# Service Bulletin

File in Section: 06 - Engine  
Bulletin No.: 13-06-01-002  
Date: July, 2013

**Subject:** Conversion of Engine RPO LZG with Active Fuel Management to Non AFM

**Models:** 2007 Chevrolet Impala VIN Code R (RPO LZ8)  
2008 Chevrolet Impala VIN Code 3 (RPO LZG)  
Equipped with 3.9L Engine

3346615

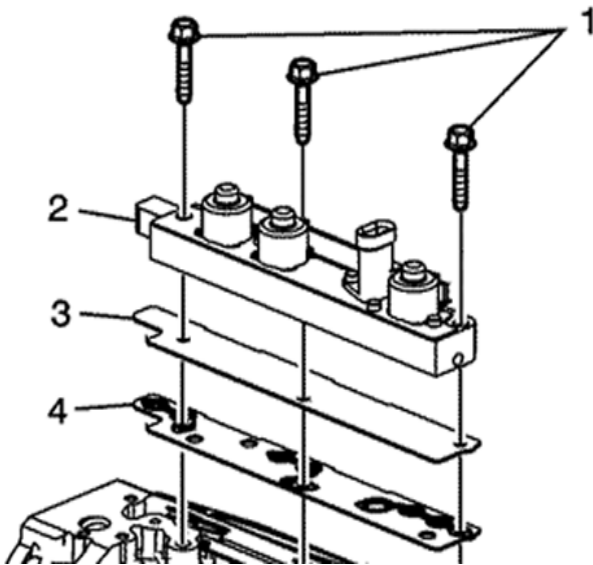
4. Install the new camshaft. Refer to Camshaft Installation in SI.
5. Install the lifters into the engine. Refer to Valve Lifter Installation in SI. Install the 6 non-AFM lifters and lifter guide removed during disassembly into the same lifter bores they were removed from. Install the 6 NEW lifters and lifterguide included in the conversion kit into the AFM lifter bores.

**Important:** Discard the valve lifter guide retainer (2) and bolts (1). They are not used during assembly.
